# INFORMATION BULLETIN

## D4K/Mirage 4K Portrait Mode

This bulletin advises that existing D4K and Mirage 4K projectors can be used in portrait mode. No physical upgrades are required but we strongly recommend upgrading to the latest software version.

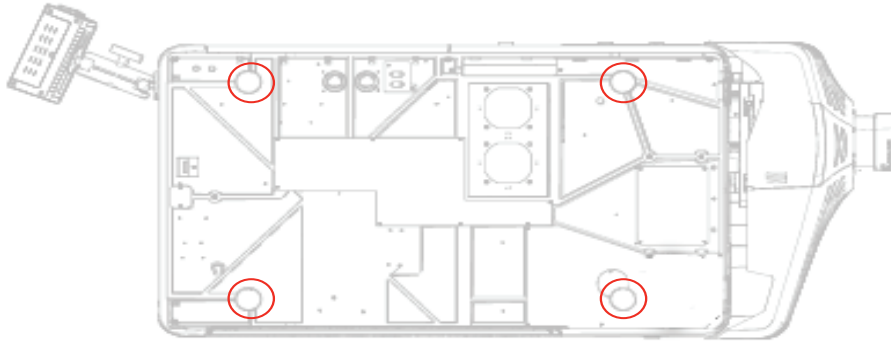
For portrait mode, the projector must be oriented with the lamp door facing downward. Failure to orient the projector correctly can result in damage to the projector.

The mounting frame must interface with four M12 holes (normally used for projector feet) on the bottom side of the projector. Mounting bolts must be grade 8.8 or higher and torqued to 60 ft-lbs. The tilt angle for the projector must not exceed  $\pm 15^\circ$  pitch/roll.
